From: [Youngman, Catherine A](#)
To: [Steinhauer, Suzanne \(COMM\)](#)
Subject: PUC DOCKET NO CN-12-113
Date: Thursday, November 15, 2012 6:01:20 PM

Below are my comments regarding the Hollydale 115kV High Voltage Transmission Line ["HVTL"] Project, Certificate Of Need scoping, docket 12-113:

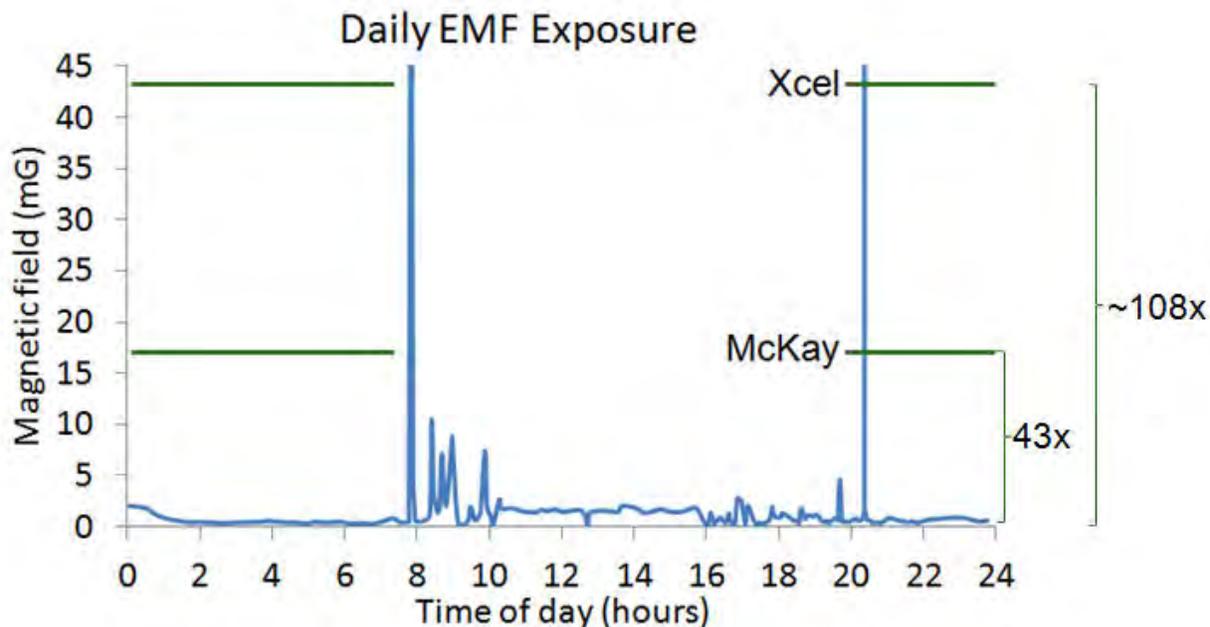
- iv. The McKay profile shows that at 60 feet – the approximate distance from the Existing Line to my children’s bedroom windows – the magnetic field will be approximately 17 to 30 mG, depending on which side of the pole our property will end up. The Xcel profile shows this value to be approximately 33 to 43 mG.

- v. Below is a profile of EMF exposure by an adult over a period of one day (<http://www.emfs.info/Sources+of+EMFs/exposure/>). The profile shows that during the night hours, the person was exposed to approximately 0.4 to 0.5 mG on average. The plot also shows thick green horizontal lines, which indicate the chronic exposure my children will suffer. The bottom green line is at 17 mG, in accordance with Mr. McKay’s “best case” profile. The top green line is at 43 mG, in accordance with Xcel’s “worst case” profiles.

- vii. To summarize: if the proposed line is granted permit, my children will be chronically exposed to 17 to 43 mG, compared to a normal value of 0.4 mG. **That translates to chronic exposure of 43x to 108x the normal levels of a possible carcinogen for ten hours every day.**

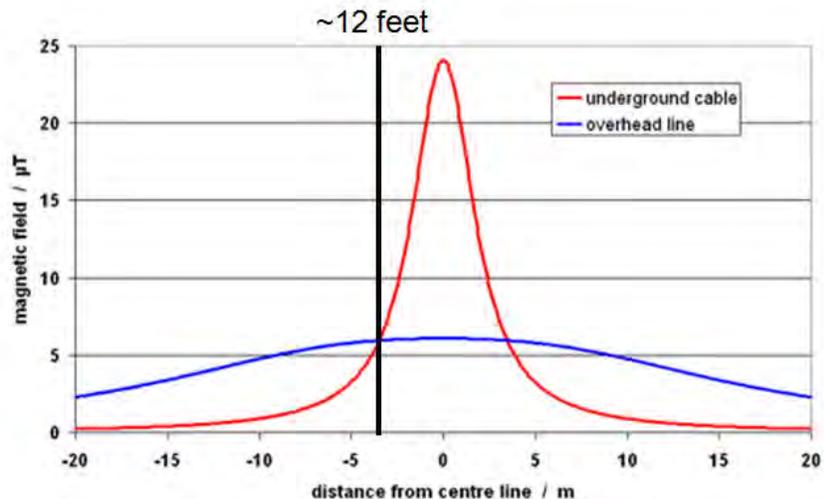
- f. The plot below compares the magnetic field profiles of the same HVTL, once in an overhead configuration and another when undergrounding the conductors (<http://www.emfs.info/Sources+of+EMFs/Underground/>). The plot shows the much stronger decay of the magnetic field profile of the undergrounded conductors, crossing the overhead configuration at 12 feet from centerline and decaying to practically zero very fast. This is because the closer together the conductors are, the more they cancel each other's magnetic fields.

- g. I request that undergrounding be considered in this environmental study as a crucial means to mitigate health, aesthetic, noise, safety, and most of the property devaluation concerns that are associated with the proposed HVTL.

**Figure A: Hamel Historical Summer Average Temperatures
And Focus Area Historical Power Demand**

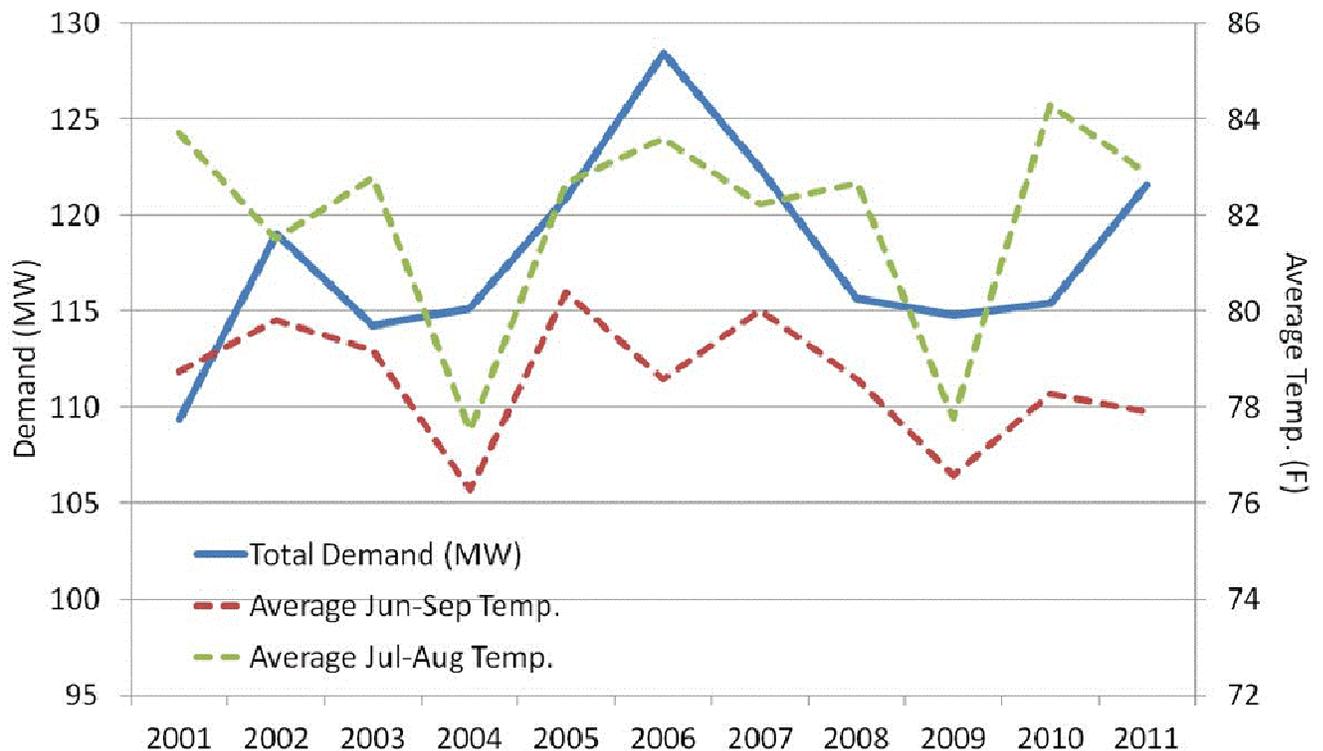
- b. Figure A in this document shows the historical total demand in MW (solid blue line) as obtained from Appendix G of the Application. It also shows historical temperatures in Hamel, which is very close to the Hollydale substation (<http://climate.umn.edu/HIDradius/radius.asp>).

- c. Figure B in this document shows the exact same plot as Figure A, but it brings up some interesting points:
 - i. The average July-August temperature in Hamel in 2010 was 0.7F hotter than in 2006. Demand, however, was 10% lower.

- ii. The most significant decrease in demand was in 2006 through 2008, but 2007 and 2008 June-September average temperatures were higher than or equal to that in 2006.

- iii. Significant '09-'10 average temperature increases (1.7 June-September; 6.5 F July through August) translated to only 0.5% increase in demand.
 - iv. '03 July-August average temperature was 1.3 F higher than '02, but power demand was 4% lower.

- d. What I'm establishing is that the Applicants made a causality claim that is not necessarily correct. I am showing four instances where the correlation between warming and cooling and energy demand breaks down. I request that you diligently review the actual facts behind any claims made throughout this process for which actual, fact-based evidence had not been submitted.

Figure B: Hamel Historical Summer Average Temperatures And Focus Area Historical Power Demand

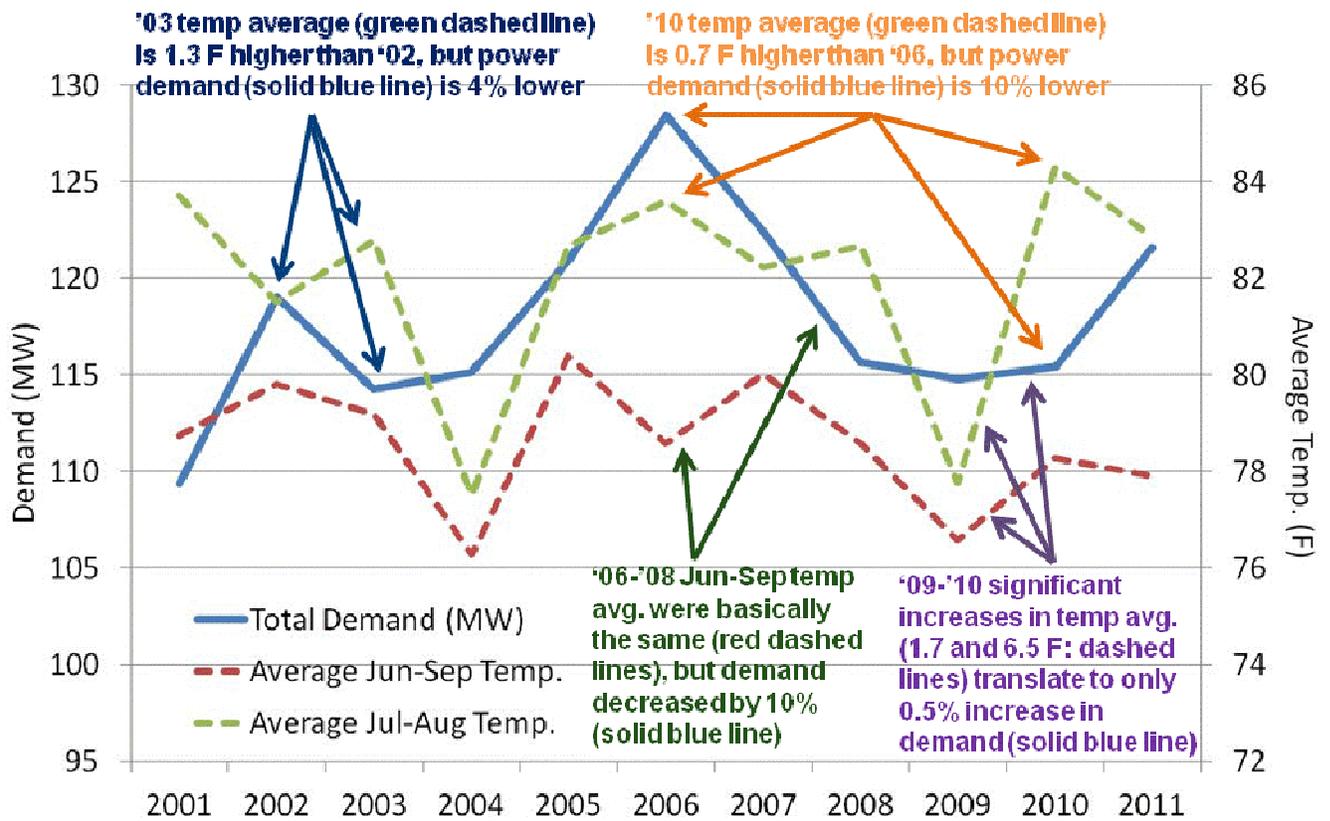
- b. Figure C in this document shows a linear extrapolation of historical overall demand data. The value in 2011 is 120.2MW whereas in 2030 it is 129.0 MW, an 8.8 MW difference. This is much lower than the Applicants' forecast differential of ~20 MW. It is unclear to me why the Applicants are using 6.1% average growth rate for the 34.5kV lines and 0.8% for the 13.8kV lines. It appears that they are taking into consideration only peak trends. In order to truly model demand growth based on historical data, all data should be considered.
